BURLINGTON DEVELOPMENT REVIEW BOARD

AGENDA

MEMORANDUM

TO: Development Review Board
FROM: Ryan Morrison, Associate Planner
DATE: September 21, 2021
RE: ZP-21-577; 63 North Avenue

Title: Pearl Street Pipe & Beverage

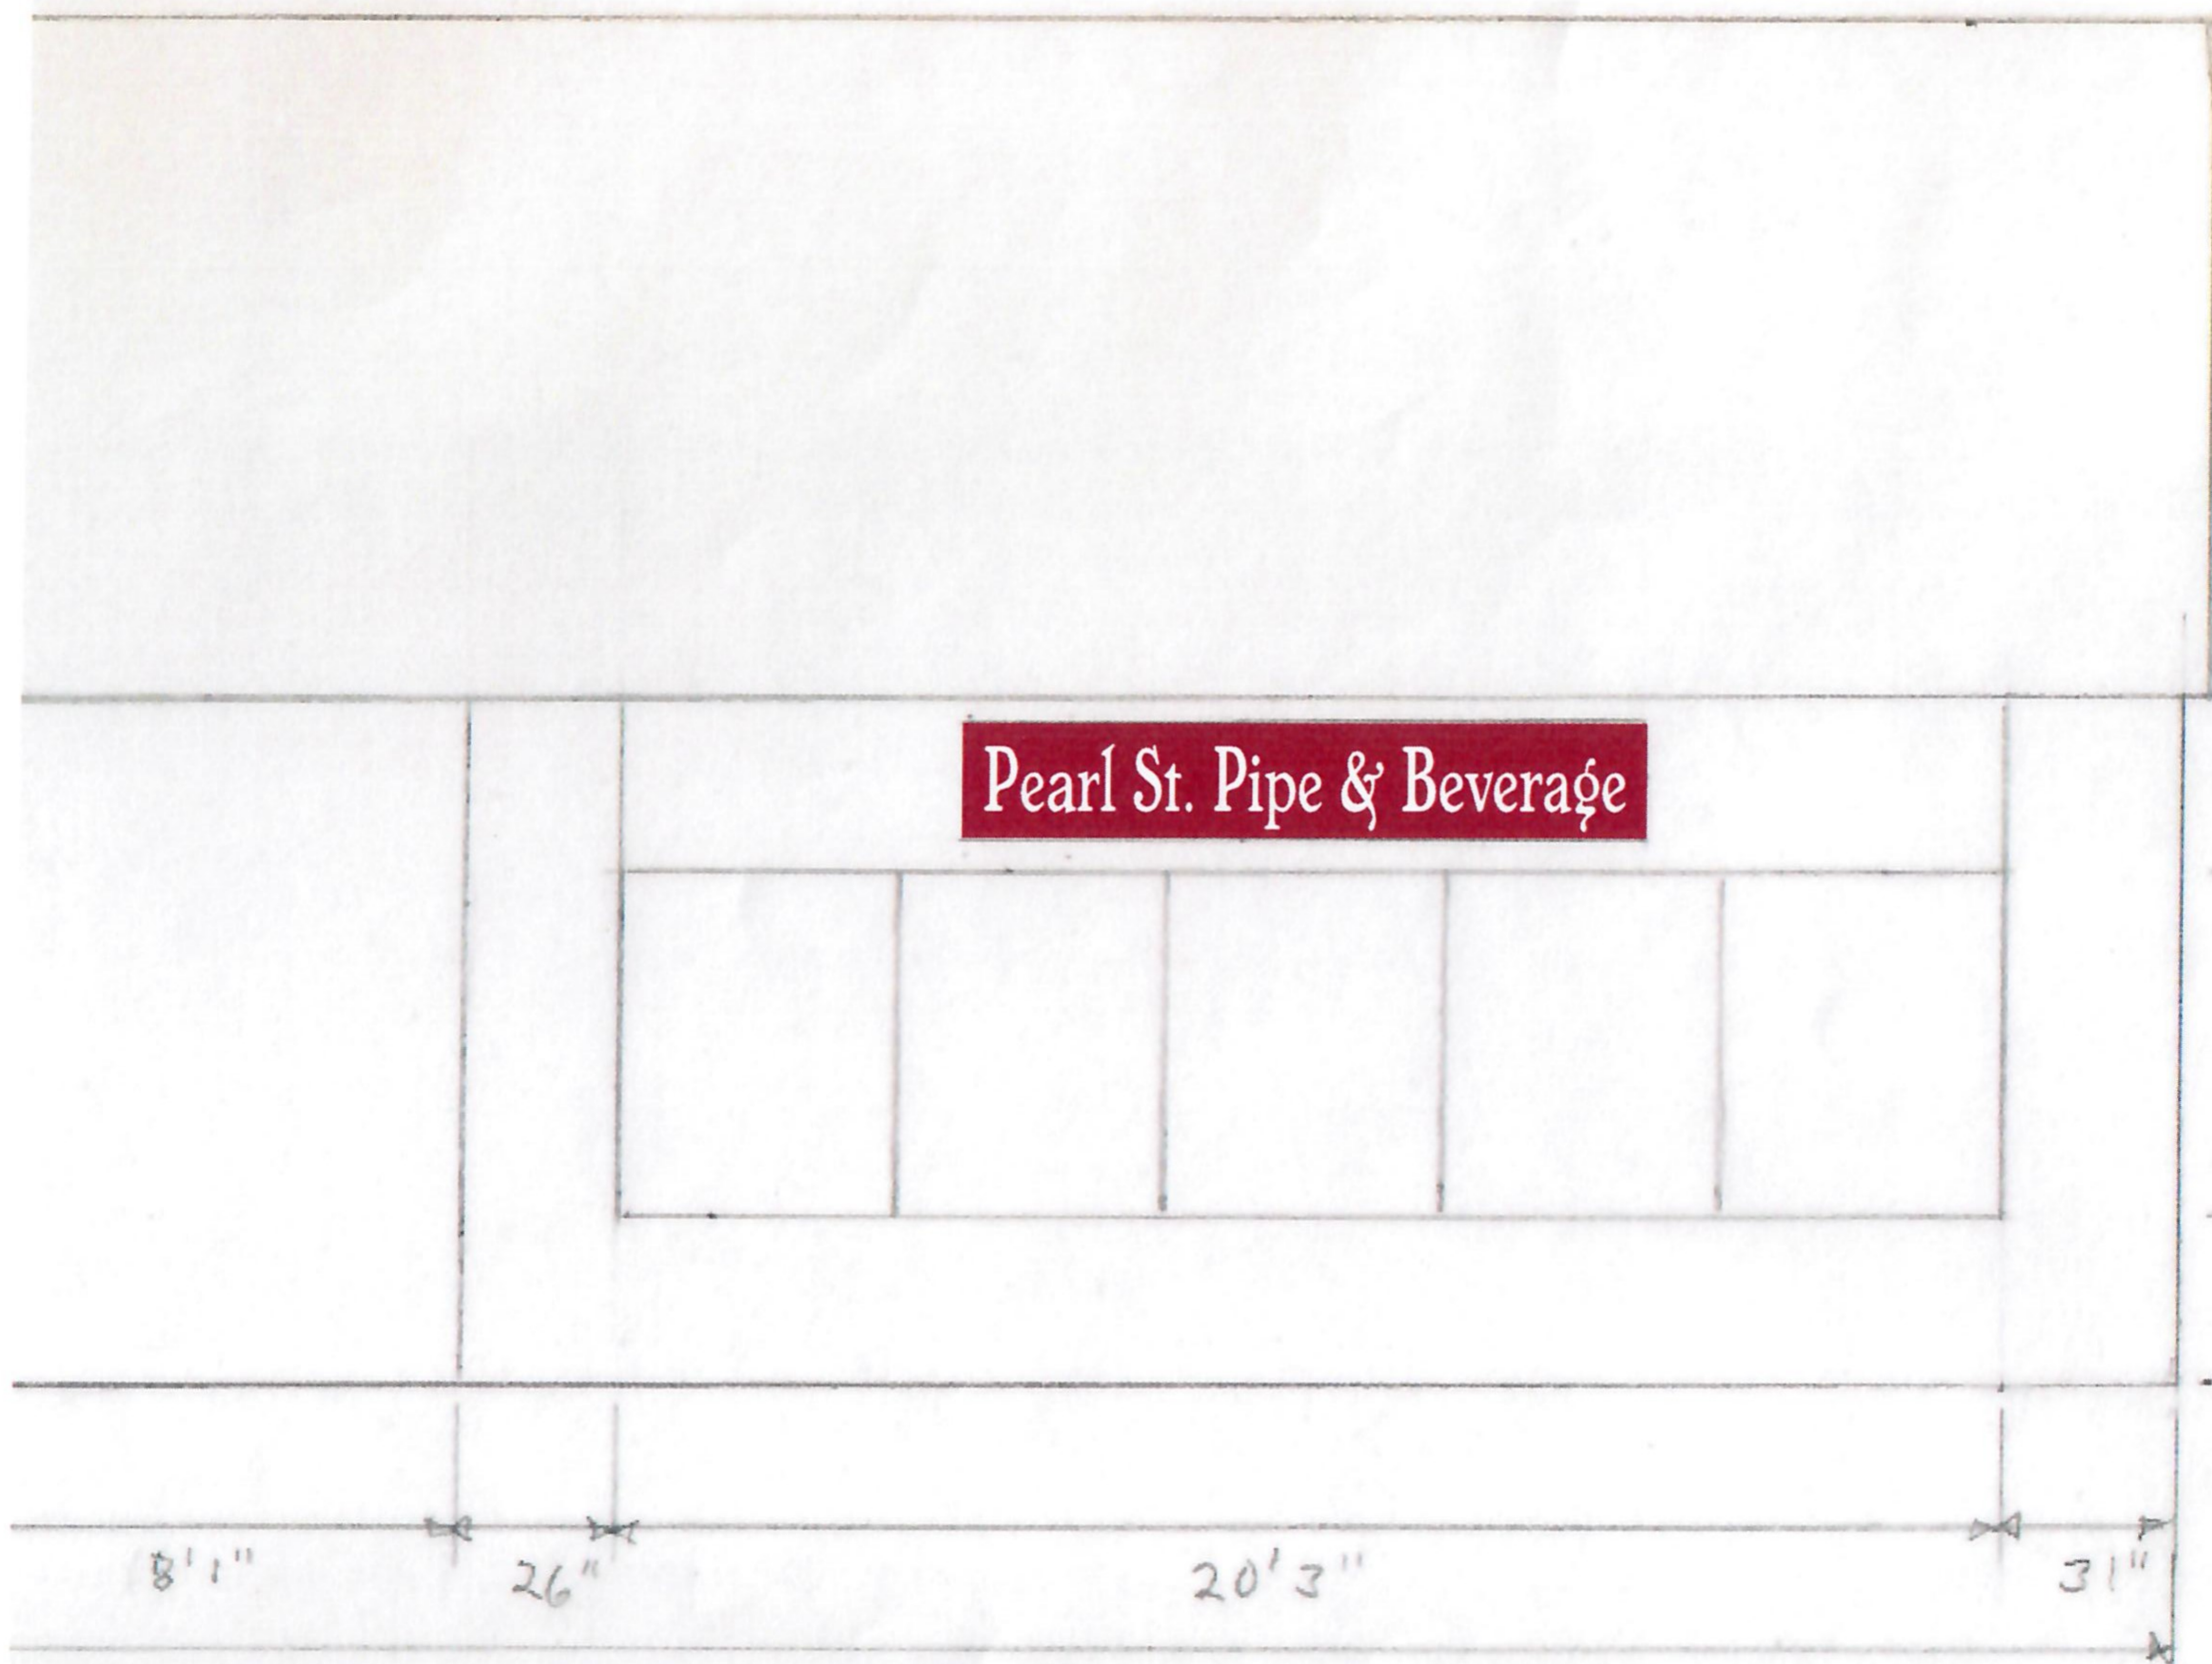
The Pearl Street Beverage was damaged by a fire July 1, 2020. There were two existing wall signs, permitted April 1980, sized 18" x 12', and 2' x 16'. (Permit #80-857.) The applicant requested a replacement sign 20' x 10' (16.66 sf.)

A conforming wall sign in a residential district is limited to 6 sf. (**Section 7.2.13**)
